Access Compliance Report

Public Rights-of-Way

(Curb Ramps)

| Intersection ID: 52289 | Main Street: TROJAN_DR | Cross Street: DIXIE_RIVER_RD | Location: N |

| ADA ID: 8631DB54AB0F | Ramp Type: Perp | Initial Pass/Fail: Fail | Overall Compliance: No |

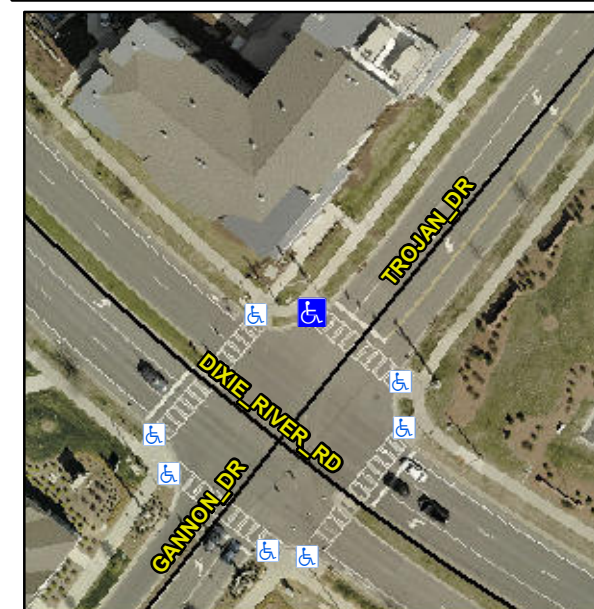
Not Found, R304.2.2, R304.5.3

| Compliance | Description | Data | Compliance | Description | Data |
|------------|-----------------------|-------|------------|-----------------------------|------|
| N/A | Ramp Length (in) | 68.0 | No | Ramp Slope (%) | 12.3 |
| Yes | Ramp Width (in) | 48.0 | No | Ramp XSlope (%) | 3.2 |

Remove & Replace Entire Ramp.
